SERVICE & PARTS TECHNICAL INFORMATION

79-C-1

TR7 CONVERTIBLE SPOILER

TR7

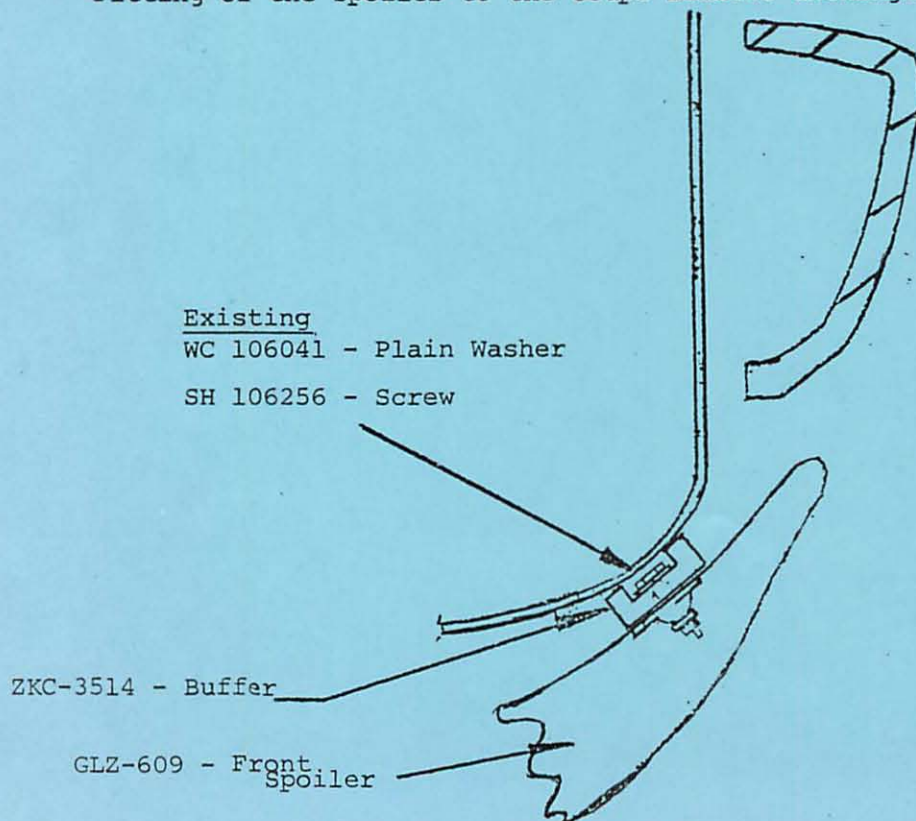
The front spoiler must be modified before fitment to the TR7 convertible. This is due to the use of a harmonic front bumper that requires clearance at each end for vertical movement.

When fitting the spoiler to the convertible it is absolutely essential that the outer two (2) bolts are not secured to the fender. Instead, the outer "riv-nuts" on the spoiler are to be used to mount two rubber buffers (see illustration), part number ZKC-3514. The buffers are to be fitted to the spoiler using two short bolts and small flat washers from the installation kit before putting the spoiler on the car. The remaining three bolts secure the spoiler to the vehicle.
